JOINT REGIONAL PLANNING PANEL (Sydney East Region)

JRPP NUMBER:	2013 SYE 049
DA NUMBER:	LDA 2013/0220
LOCAL GOVERNMENT AREA:	City of Ryde
PROPOSED DEVELOPMENT:	<p>Demolition of all existing structures across the existing site.</p> <p>Construction of a part 7 storey and part 2 storey mixed use development with a total gross floor area (GFA) of 6,957m².</p> <p>The application includes development on both private and public land (road reserve), the latter being owned by the City of Ryde Council.</p>
STREET ADDRESS:	<p>134-140 Victoria Road and 2-10 Wharf Road and adjacent land within the road reserve at Gladesville.</p> <p>The total “site” area is 2,294m², comprised of 134-140 Victoria Road, 2-10 Wharf Road (total 1,492 m²), Pearson Lane (356 m²) and the Wharf Road road reserve (446 m²). The total area of public land is 802 m² or 35% of the site.</p>
APPLICANT:	Hindmarsh Development Australia Pty Ltd
NUMBER OF SUBMISSIONS:	A total of 65 submissions have been received. 48 submissions raise various objections and 17 submissions provide support.

Assessment Report and Recommendation

Figure 16: North-east elevation of Victoria Road showing the ground floor shopfronts.

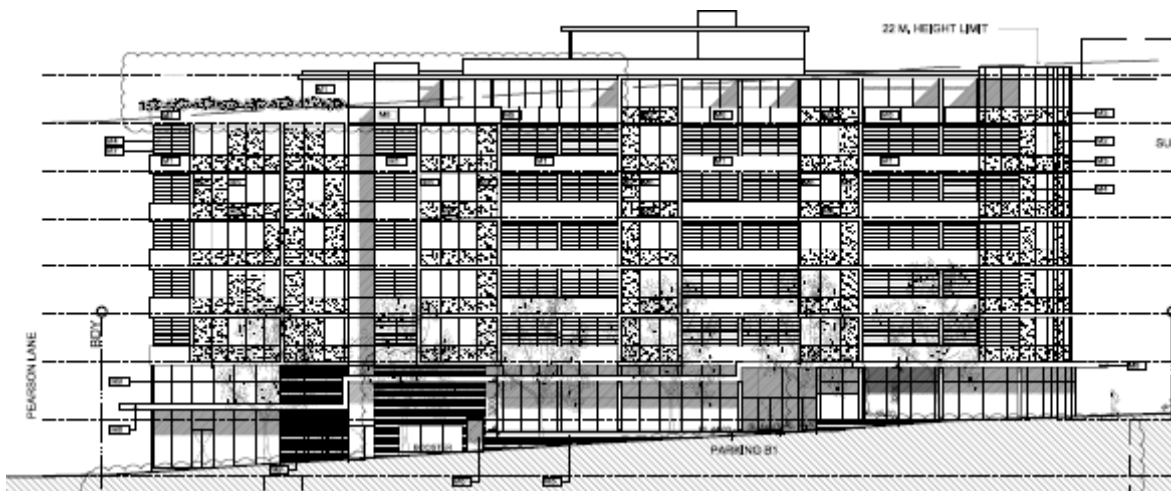
The panel supports the key site diagrams requirement for activation along Victoria Road. The downward slope along Victoria Road results in retail above street level and a blank wall along the eastern end of site. The panel recommends retail space step to provide better access to the footpath. This would facilitate flexibility in tenancy size and configuration over the life of the buildings.

Comment: The Victoria Road retail tenancies have been stepped and the extent of blank wall/non shop-front minimised. The corner of Victoria Road and Pearson Street has been amended to include a 2 storey shopfront, as shown in the perspective drawing copied below in Figure 15. Figure 16 shows shopfronts along Victoria Road.

Figure 17: Areas of compliance and non-compliance with the 22m height standard, viewed from Victoria Road.

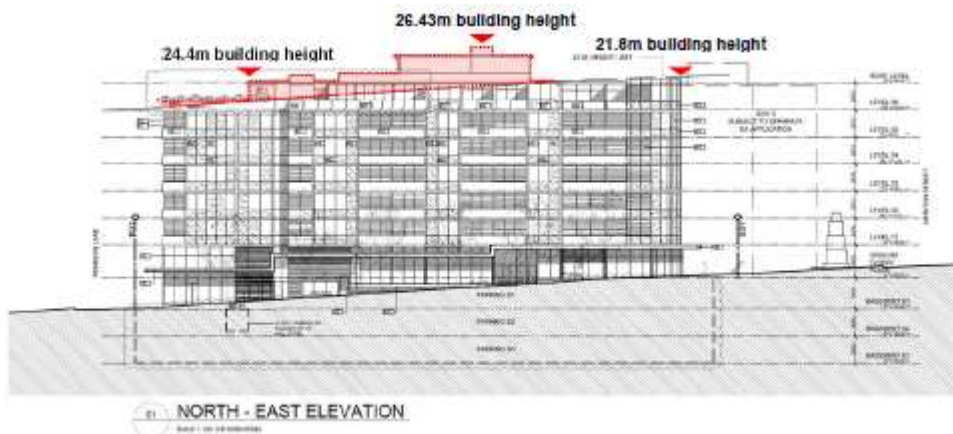
At the eastern end of the building, fronting Victoria Road the height standard is met. Within the centre of the building, prior to the stepping, the maximum non-compliance is approximately 2m (other than the lift overrun). As the building steps there is again compliance with the height standard. The highest point of the building is approximately 26.43m in the location of the lift overrun which occupies a small portion of the centre of the centre of the building area.

Images provided by the architect showing the areas of compliance and non-compliance are included below. The 22m maximum height is shown as a red dotted line across the top of the building:

Figure 18: Areas of compliance and non-compliance with the 22m height standard, viewed from south of the site. Note that the areas of non-compliance are within the centre of the building and do not extend to Pearson Lane.

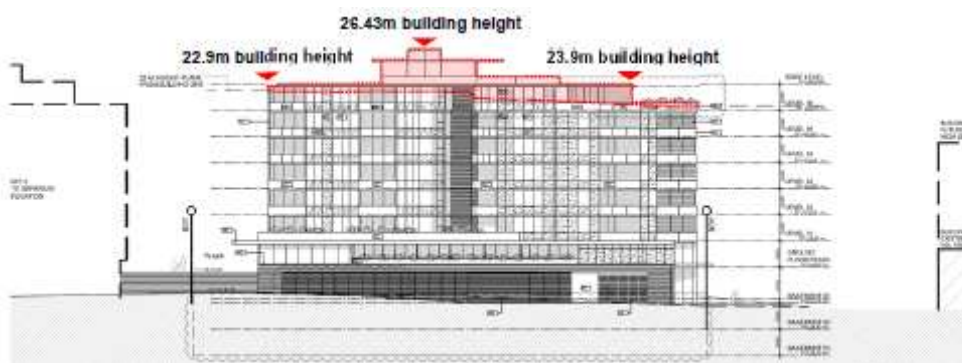
For a section at the rear of the site the building exceeds the height standard and is a storey greater than the RDCP 2010 but it is acknowledged that this is only for a relatively small section of the building adjacent to Pearson Lane and this component of the building has minimal visual bulk or overshadowing impacts, as compared to a compliant envelope in this location.

Figure 16: RDCP 2010 Key Sites built form plan

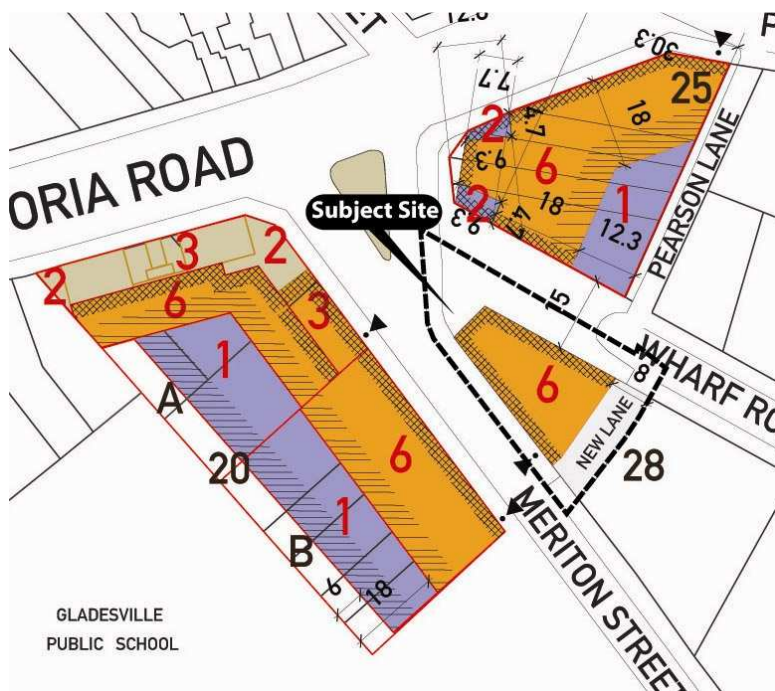
As noted in the report the DA is inconsistent with the key sites diagram for the subject site. The Key Sites diagram is shown below in Figure 16.

The DA departs from the Key Sites diagram contained in RDCP 2010. The departure, and the departures generally from the relevant planning controls in RLEP 20101 and RDCP 2010, arise largely from the development “site” being 802 sqm greater than envisaged in the “Key Site” diagram and controls in the RDCP 2010 in particular. The enlargement of the site in turn comes about as a result of the Council’s decision to close public roads and sell the land to the owner of 134-140 Victoria Road and 2-4 Wharf Road. The larger site has in turn allowed a greater volume of floor space to be achieved while at the same time meeting the maximum FSR control. In fact the proposal is well below the maximum allowable FSR. The additional floor space has been accommodated by way of a 7th storey and an additional (2nd) storey fronting Pearson Lane, as well as some relatively minor departures from the DCP setback controls.
